CANNON USA

10. This refers to your application dated November 13, 1987, for a
11. license to distribute, pursuant to Section 32.14 of 10 CFR Part
12. 32, glow lamps containing radioactive material to persons exempt
13. from licensing pursuant to Section 30.15 of 10 CFR Part 30. We
14. find that the following additional information is needed in
15. support of your license request:

Re: Application for the Specific and Possession Licenses

H. Section 32.14(b)(6) -- Labeling

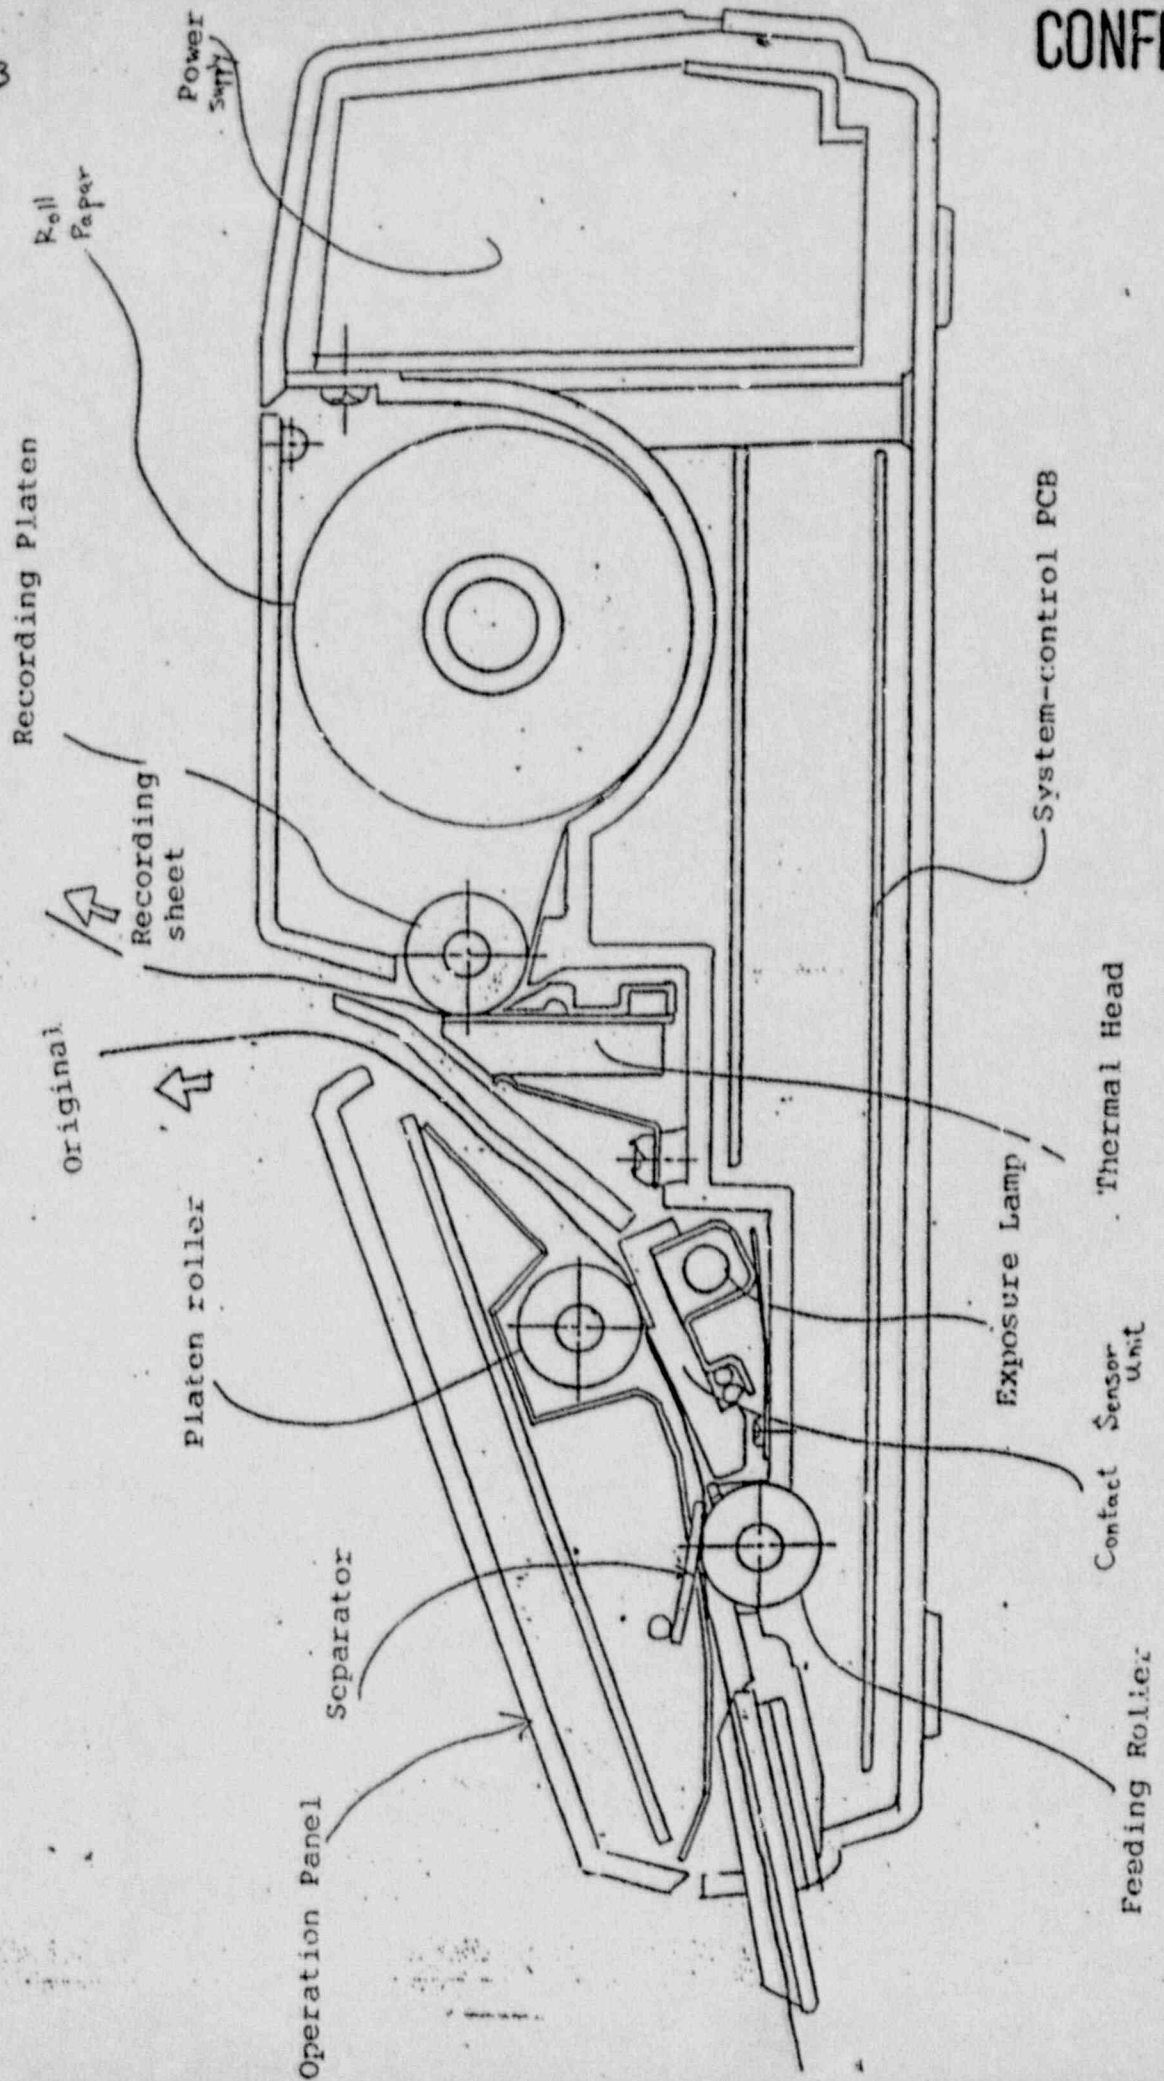
65.
66. 5. The information you provided concerning labeling indicates
67. that the contact sensor unit rather than the glow lamp
68. itself will be labeled. The exemption provided in paragraph
69. 30.15(a)(8) is for electron tubes (or glow lamps).
70. Paragraph 32.15(d) specifies that each unit (e.g., the glow
71. lamp) must be labeled. While we would consider alternative
72. labeling provisions, such alternatives must be justified and
73. shown to be equivalent to labeling the tube itself (e.g.,
74. separation of the tube from the unit is highly unlikely to
75. occur under reasonable circumstances). You should also

76. provide information to show that the label can be expected
77. to remain durable and legible ^{OVER} of the expected useful life of
78. the product and provide a sketch or drawing to show the
79. location of the label on the unit.

Attachment #1
CONFIDENTIAL

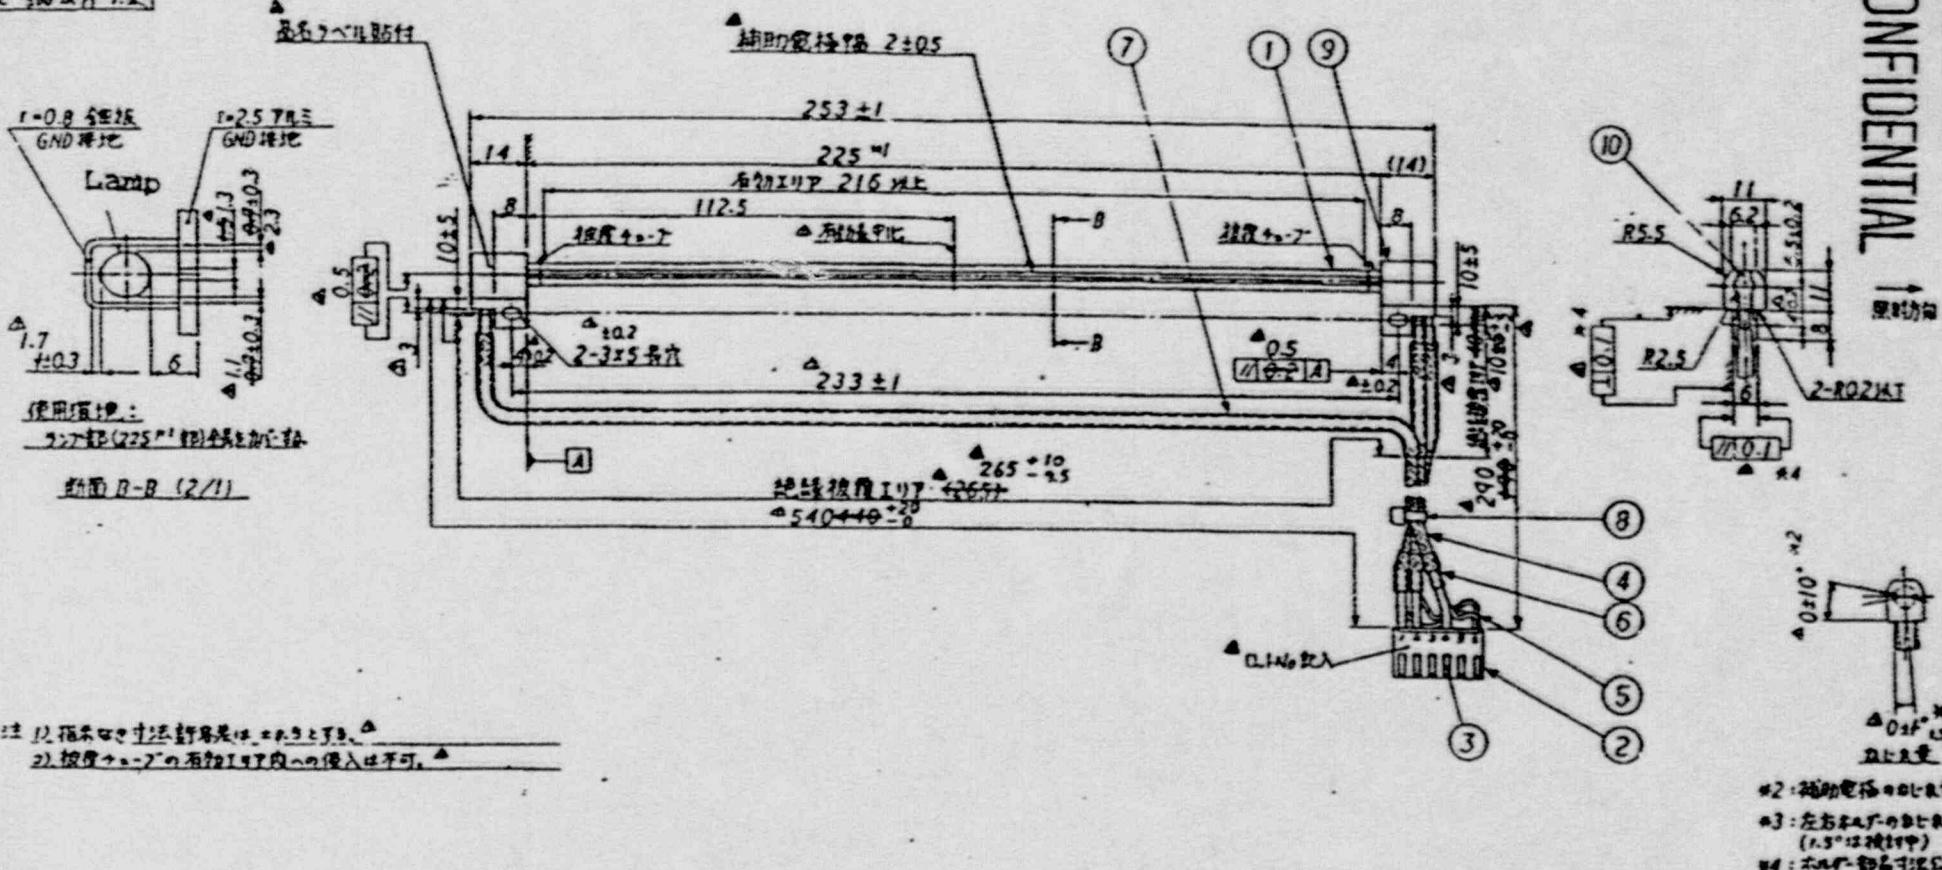
80.
81. 6. We note that the diagrams attached to your application are
82. marked "confidential." Please note that license
83. applications are available for review by the general public
84. in the NRC Public Document Rooms. You should do not submit
85. proprietary or confidential information unless it is
86. absolutely necessary. If submittal of such information is
87. necessary, you must follow the procedure specified in
88. Section 2.790 of 10 CFR Part 2. Failure to follow this
89. procedure may result in disclosure of the proprietary
90. information to the public. Please clarify.
